Model	PDC-10E I/F kit type B	Volt/Hz	Date of Modification	Serial Number
Modified Article	Ferrite Core	No serial number cut-in information		
Reason for Modification	To comply with CE mark standards.

Model	Interface Kit Type B	Volt/Hz	Date of Modification	Serial Number
Modified Article	Interface Harness	No serial number information		
Reason for Modification	To reduce noise emission

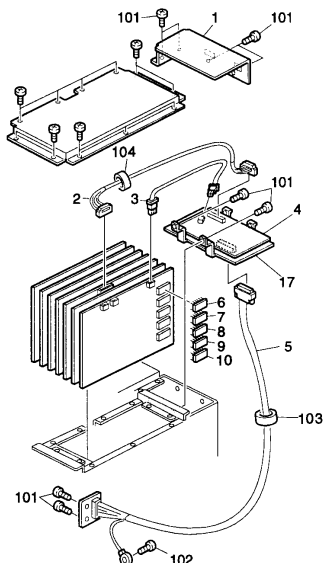
To comply with the CE mark standards, ferrite cores have been added.

New P/N	Description	Q'ty Used	Parts Catalog	
			Index No.	Page
16070534	Ferrite Core - ZCAR3035-1330	0 → 1	103	3
16070638	Ferrite Core - TFC25-15-12	0 → 1	104	3
